UNITED STATES PATENT AND TRADEMARK OFFICE

APPLICATION NO.	FILING DATE	FIRST NAMED INVENTOR	ATTORNEY DOCKET NO.	CONFIRMATION NO.
10/528,502	08/01/2005	Thomas Dörner	54651/DBP/M521	4395

Office Action Summary

DETAILED ACTION

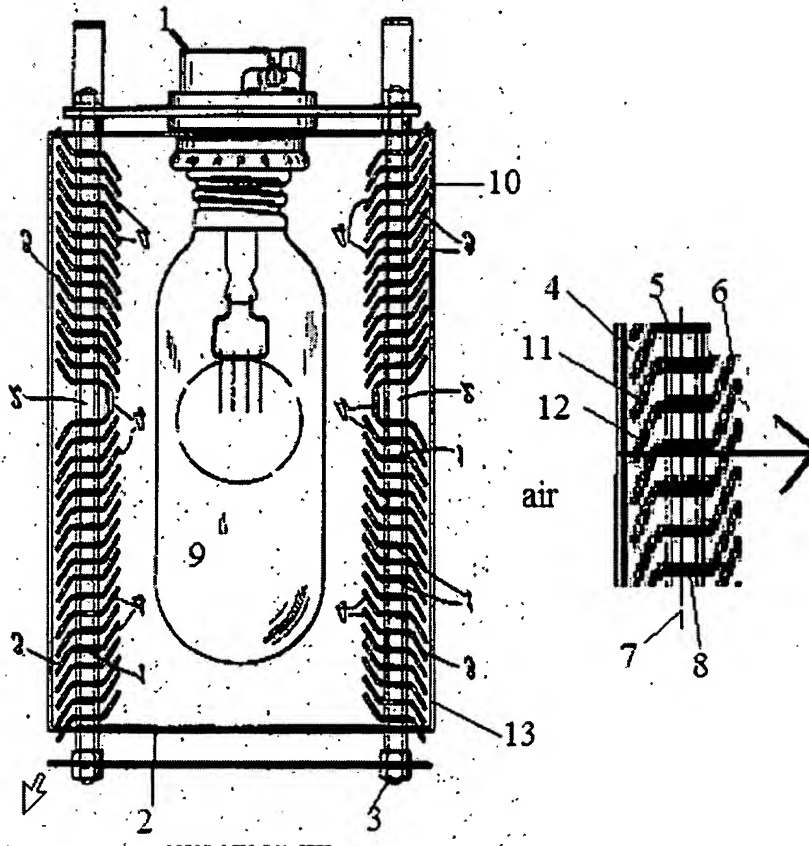
24. Claim 1: McCormack anticipates (see below) a spotlight for cinema with a light source [9], a housing with square lower part [2], cylindrical upper part [1], a transparent cover [inherent to receiving light from the source] a ventilation shaft [10] with ventilation ducts [11] mounted on housing wall [3] separated by ribs [12] with first rib section [4] and a second rib section [5] bent relative to [4] and adjoins outlet aperture [plane 7]. The ribs further comprising guide sections [6 and 8] where part [6] is bent more relative to second rib section [5] and part [8] aligns with section [5].
